MITIGATION PLAN

VILE CREEK MITIGATION SITE

Alleghany County, NC
DEQ Contract No. 5999
DMS ID No. 96582

SUBJECT: Vile Creek Mitigation Site - NCIRT Comments During 30-day Mitigation Plan Review

Figure 3 Existing Site Conditions
 Vile Creek Mitigation Site
 New River Basin 05050001

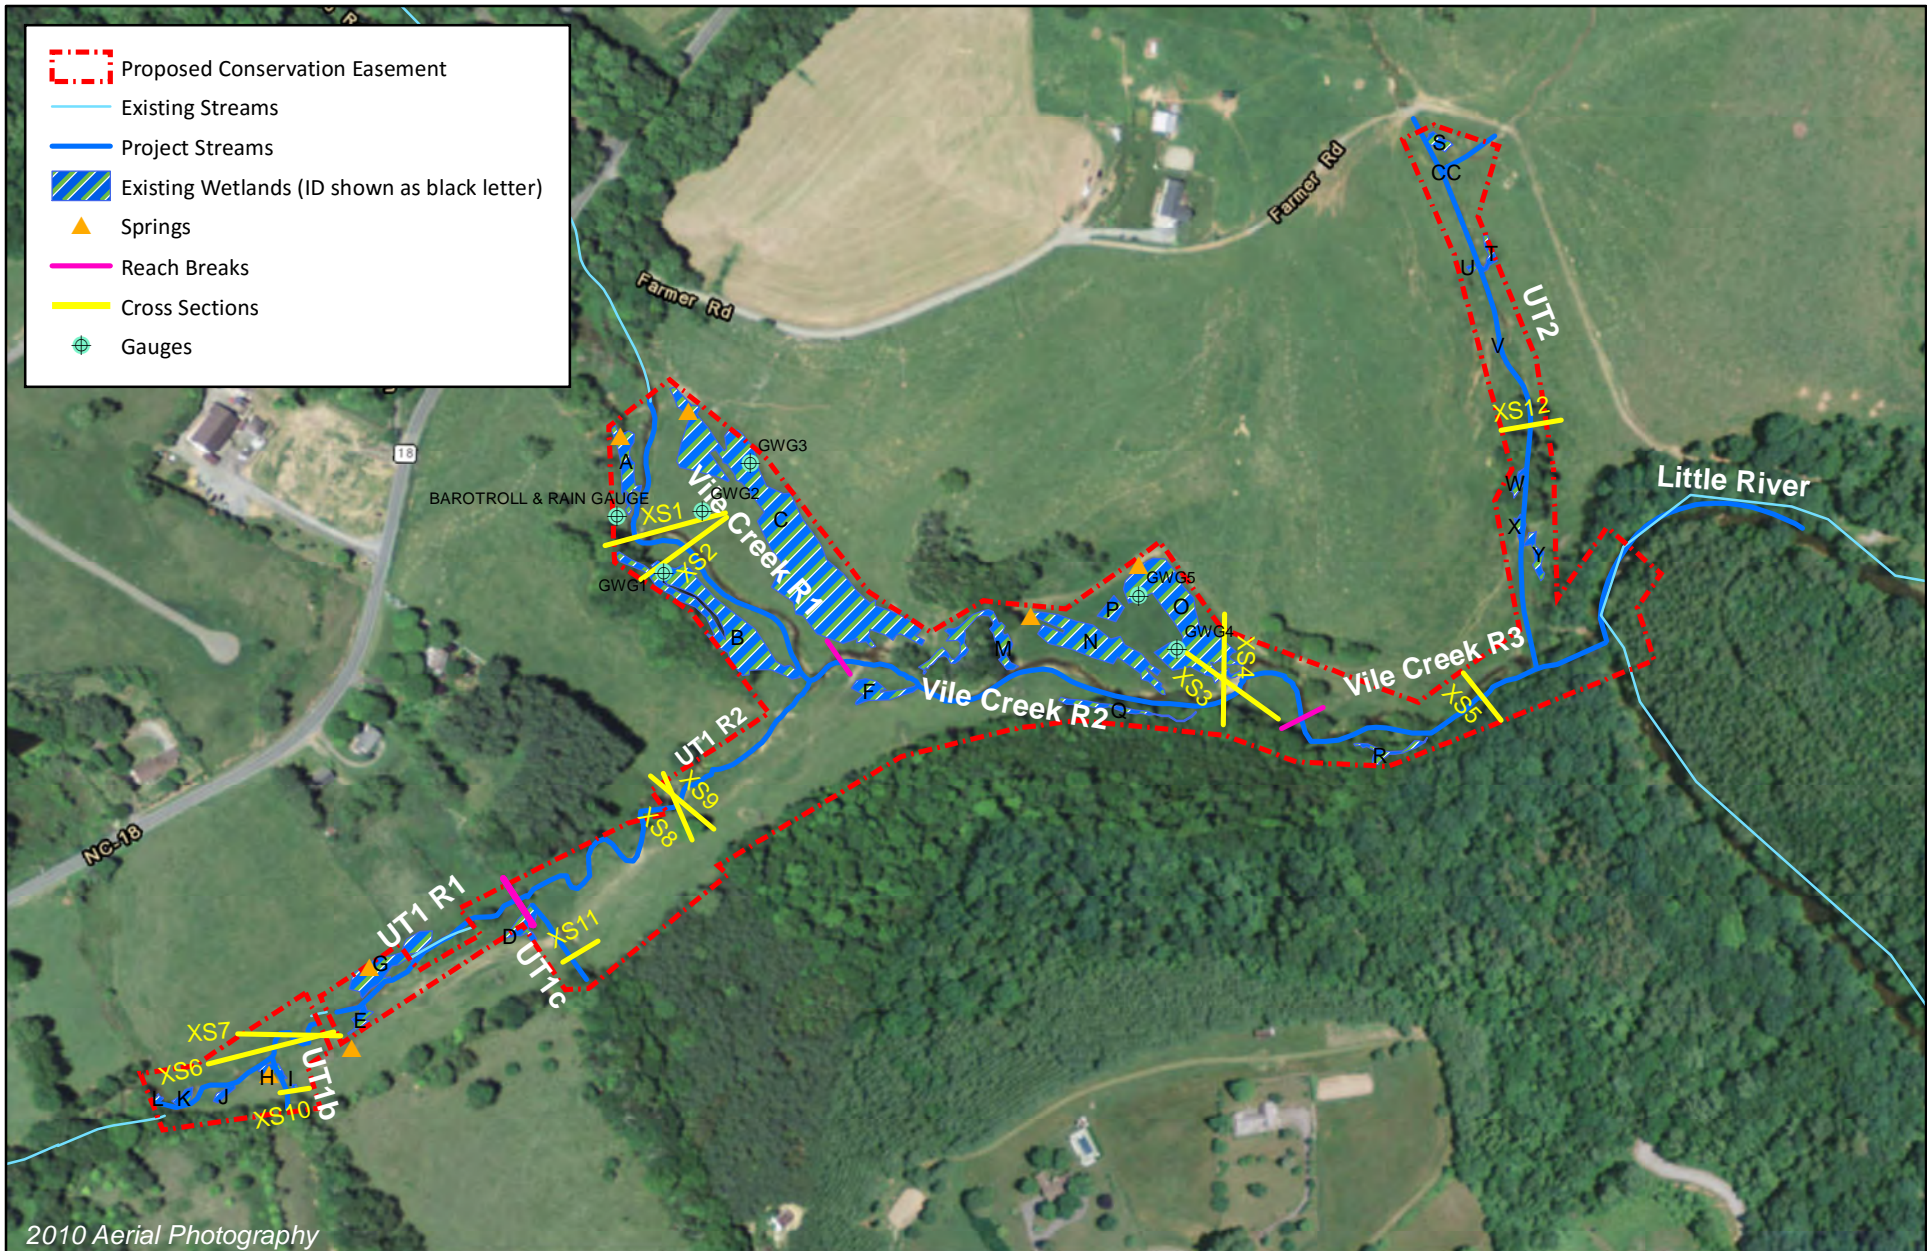
- The remnant patch of bog on the south side of Vile Creek R2 (labeled area F on Figure 3) is not categorized as a “bog cell” and is currently in the zone to be planted as trees. This is one of the best looking remnant patches of Southern Appalachian bog on the site and we recommend treating this area accordingly with any disturbed land in the vicinity planted with herbaceous plants rather than trees.

- The remnant patch of bog on the south side of Vile Creek R2 (labeled area F on Figure 3) is not categorized as a "bog cell" and is currently in the zone to be planted as trees. This is one of the best looking remnant patches of Southern Appalachian bog on the site and we recommend treating this area accordingly with any disturbed land in the vicinity planted with herbaceous plants rather than trees.

We have depicted all of the springs that we are aware of on Figure 3.

Figure 10 Proposed Design Overview
 Vile Creek Mitigation Site
 New River Basin 05050001

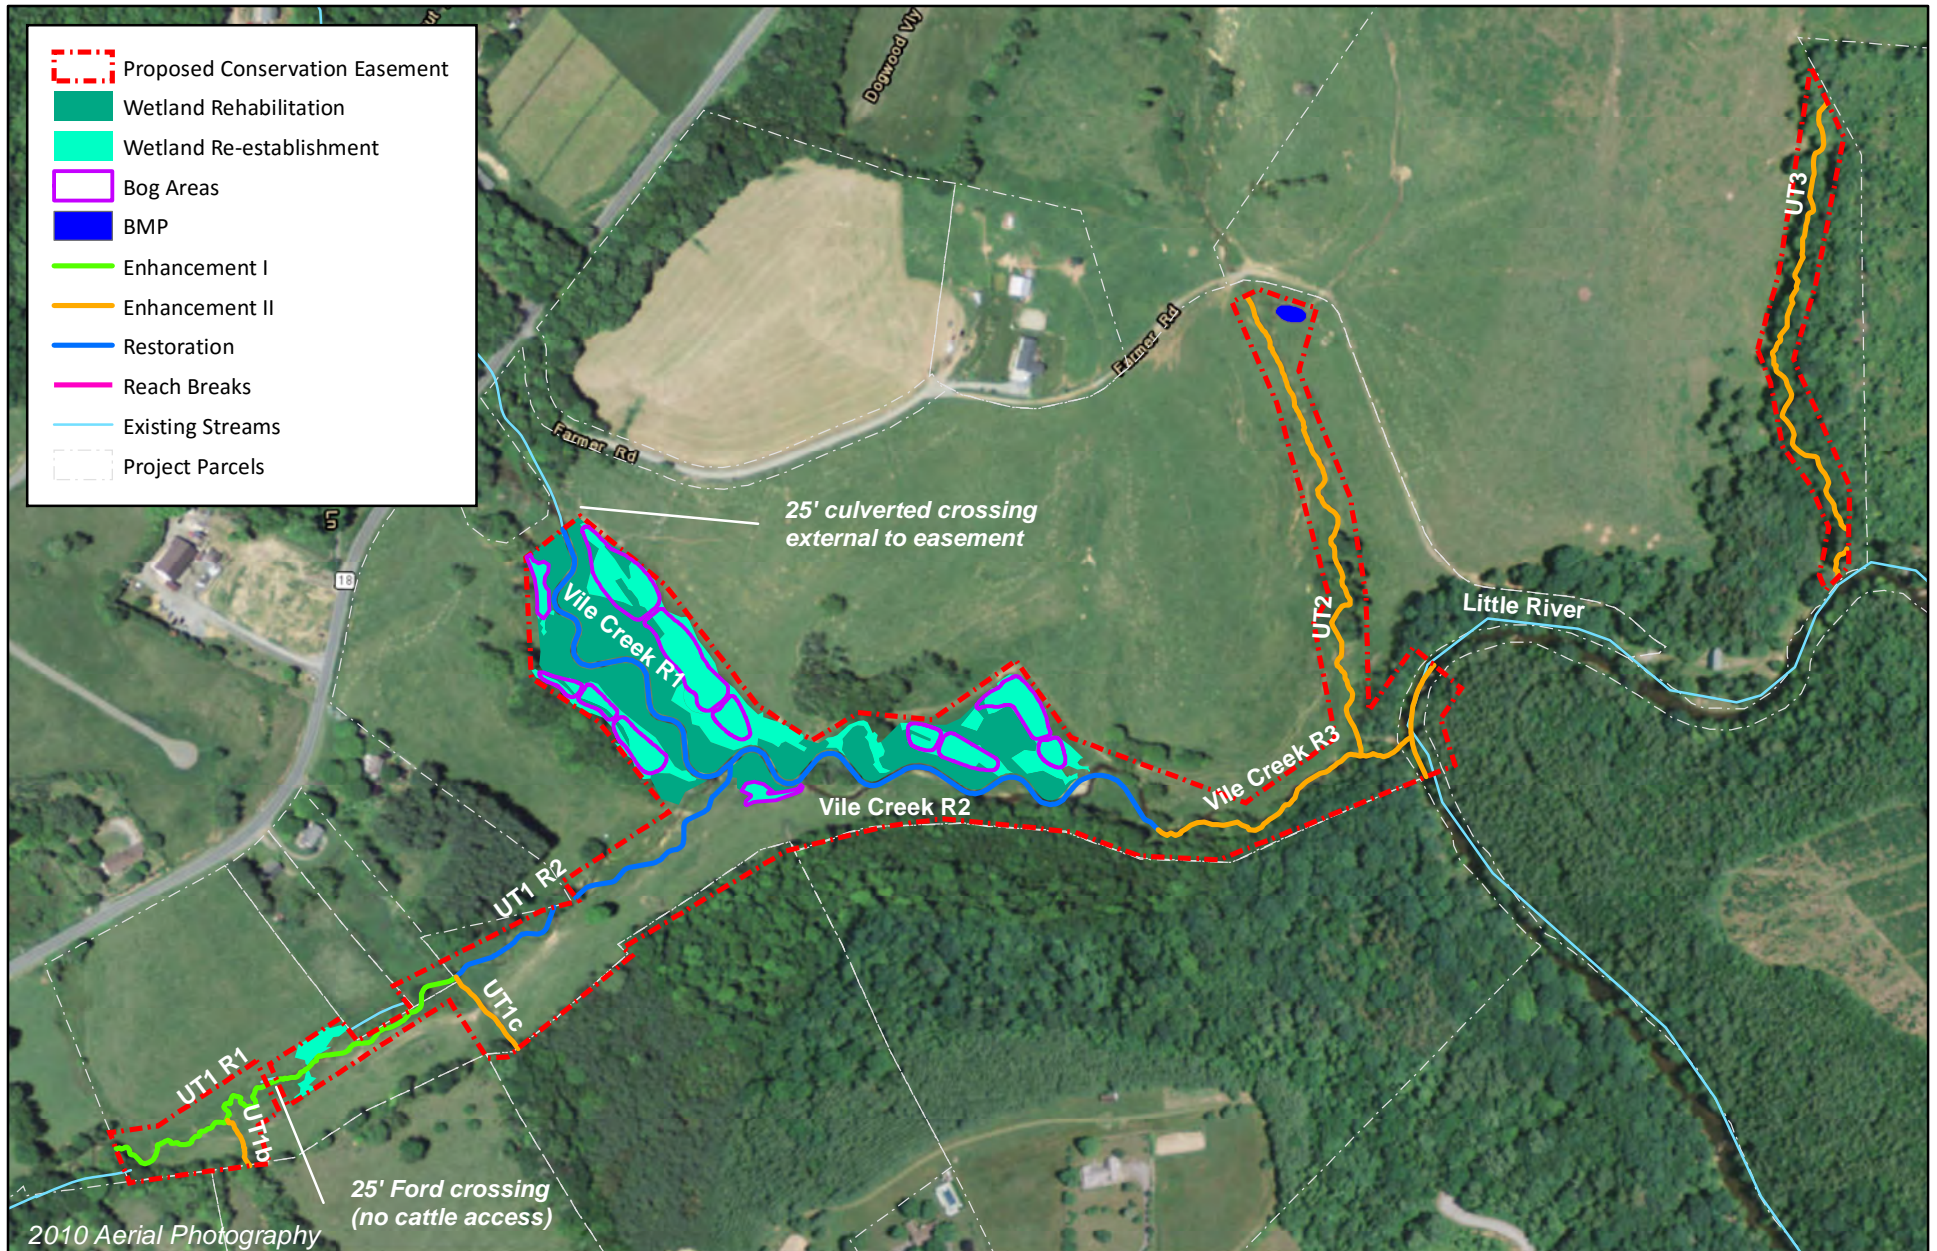
3. DWR has the following concerns and recommendations regarding the design of the bog cells;
 - a. Extensive construction and manipulation of the floodplain with significant berms that would likely remove portions of the floodplain from wetland restoration status,

- b. The berms would likely result in mostly ponded water, resulting in more standing water than saturated soil needed to promote and develop the bog habitat. While some open water may be preferable for bog turtle habitat, DWR believes the current design would yield more open water and less of a wetland mosaic (saturated areas in addition to some drier areas).

- c. DWR would support the design and construction of several bog cells rather than all the wetland area be dedicated to bog cells.
- d. DWR would also recommend lowering the berm height on the design, which may allow the berms to be included in the wetland restoration (development of hydric soil indicators) acreage and result in less open water and more saturated soil for the respective bog cell.

There was a mistake on the GIS figure showing the proposed conditions submitted with the original mitigation plan. On that figure, the extent of the wetland reestablishment area was shown to be smaller than it actually is proposed to be. This figure made it appear that the bog areas took up more of the wetland area than they actually do. In fact, the bogs are only 30% of the total wetland mitigation area. The figure has been revised for the final mitigation plan (Figure 10).

*We have reduced the number of berms from 14 down to 10. We have also redesigned the berms to be lower than they originally were – approximately half of the original height. We do think the berms will be wet and, if successful, will be counted in the acreage of wetland rehabilitation. **Please refer to new plan sheets 3.7-3.11 and revised Figure 10.***

*We have altered the design to reduce the amount and height of berms. This will reduce the amount of standing water significantly. We do want to keep some berms within the existing ditches to slow the movement of water through the ditches and promote a higher groundwater table for surrounding wetlands. The area of the bogs will be significantly expanded. Please refer to new plan sheets (**plan sheets 3.1-3.11**) and revised Figure 10.*

We will adjust the plan to include area F as a bog area. Refer to the revised Figure 10.

APPENDICES

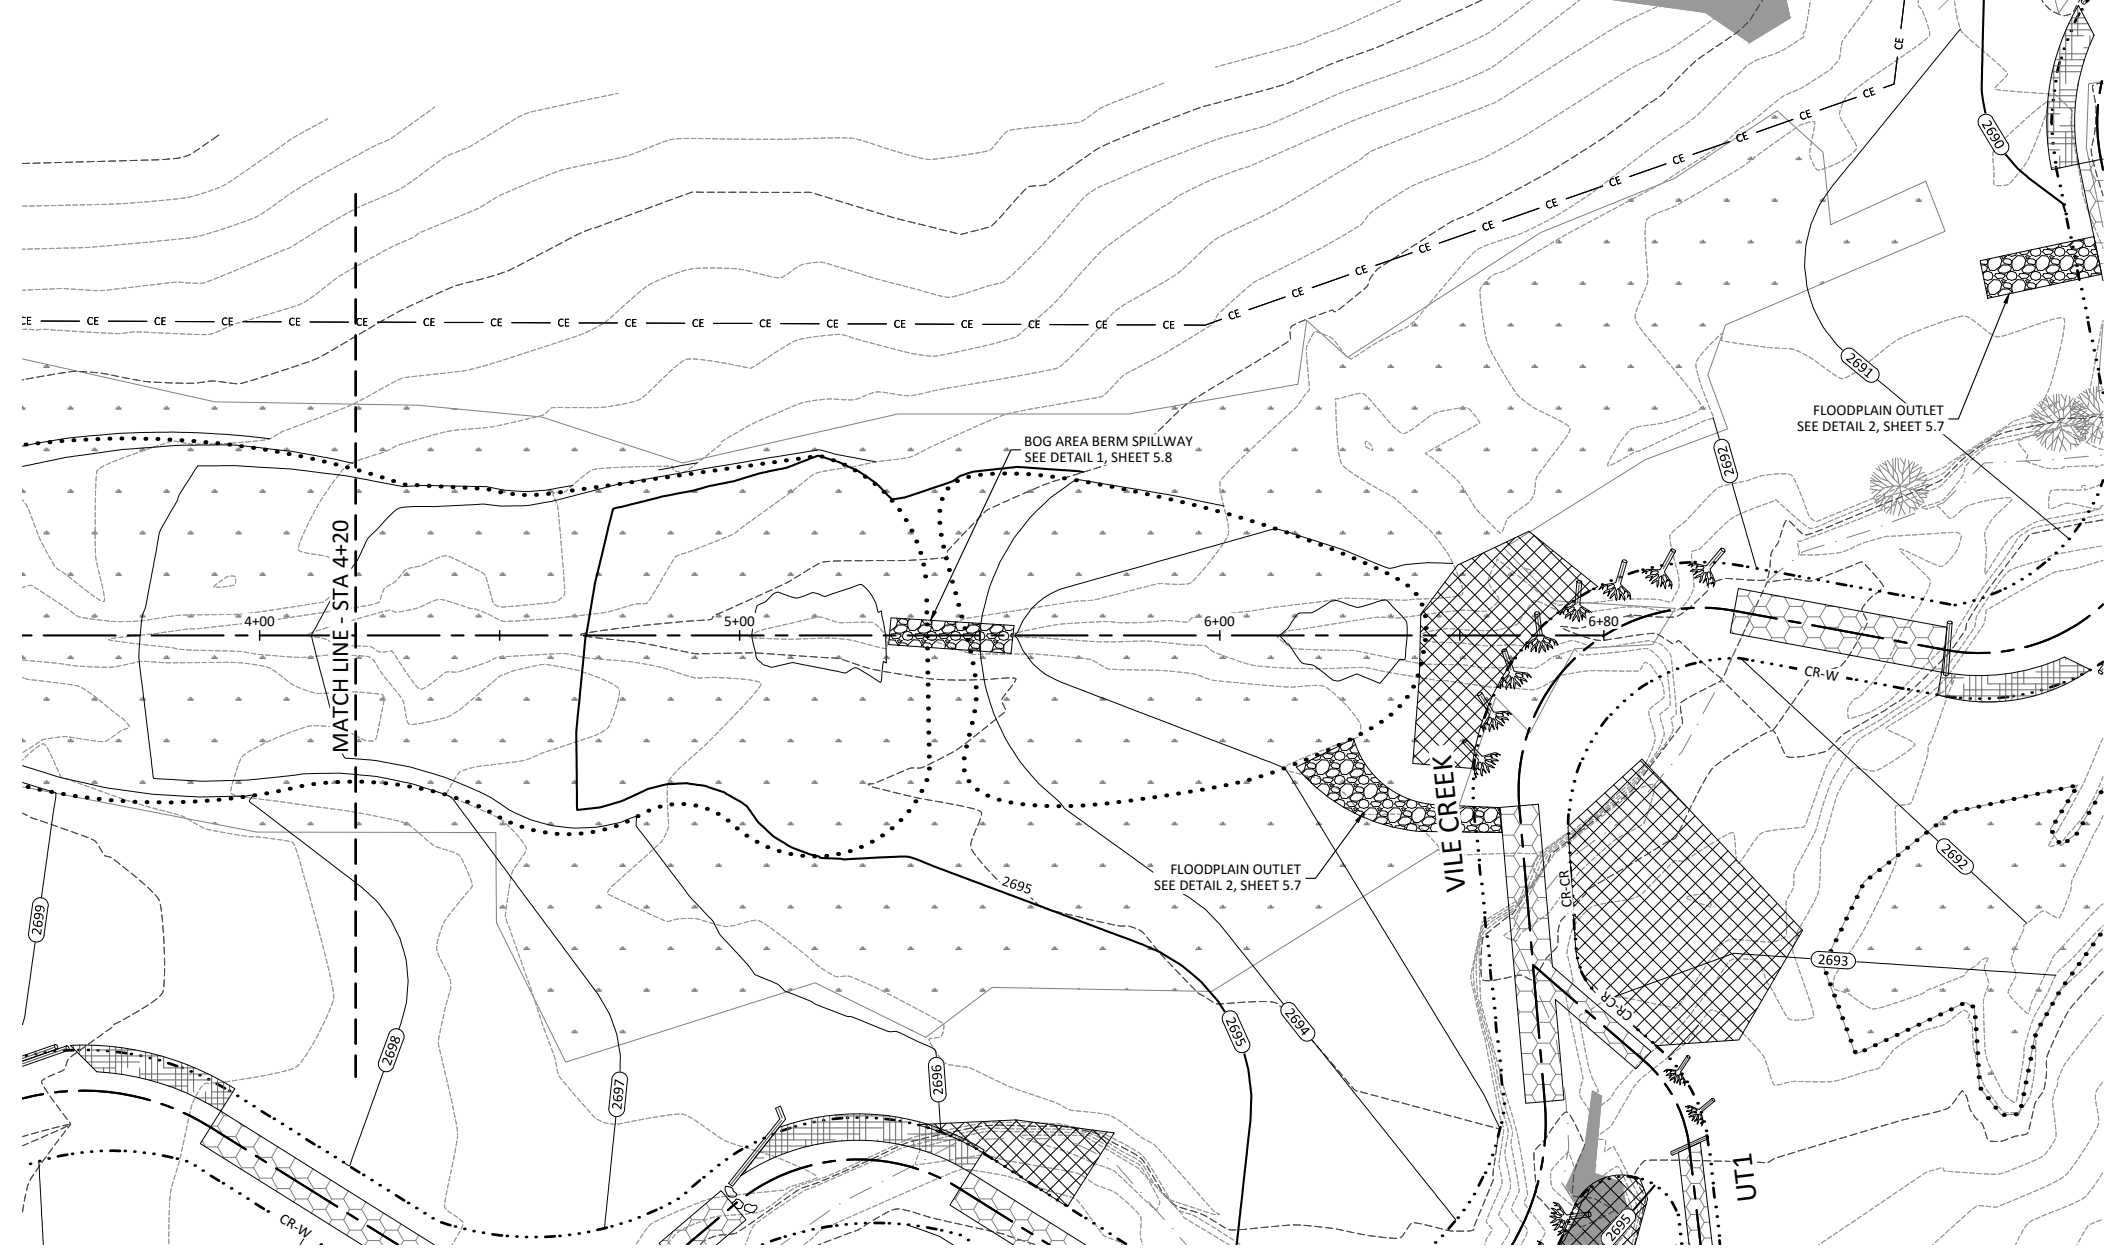
7. DWR recommends the designer be wary of lateral hydrologic “pop-out” on the streambank where the wetland areas drain into the stream, especially if these areas drain into a meander bend as shown on design sheet 3.8. DWR recommends supplemental stabilization measures be considered for these areas.

We have redesigned the swale to carry overflow into the adjacent channel so that it enters the channel at the riffle upstream of the meander bend mentioned (plan sheet 3.8). The swales will be armored with native rock for stability. The streambanks where the swales discharge will also be protected from erosion.
